podkładka szczotki Makita
459219-2 (nowy numer
413829-9)

D8475

Title	Change of Brush A complete, Gear housing, Brush stopper Addition of Earth plate A
Model	DSL800, XLS01
Country	All countries
Description	For countermeasure against static electricity: • Brush A complete, Gear housing and Brush stopper will be changed. • Earth plate A will be added.

[2] Change of Gear housing

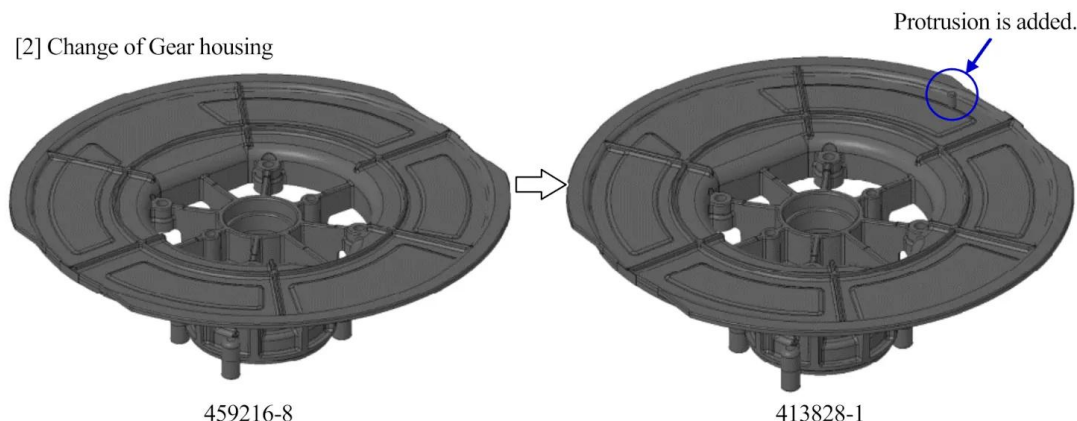
[1] Change of Brush A complete

Item No.	Current part	Q'ty	I/C	H/S	S/P	New part	Q'ty	Note
[1]	043	BRUSH A COMPLETE 140J85-5	1	S	OK	A	BRUSH A COMPLETE 141C96-1	1	Interchangeable as a set
[2]	029	GEAR HOUSING 459216-8	1	S	OK	A	GEAR HOUSING 413828-1	1	
[3]	040	BRUSH STOPPER 459219-2	1	S	OK	A	BRUSH STOPPER 413829-9	1	
[4]	094			S			EARTH PLATE A 347816-5	1
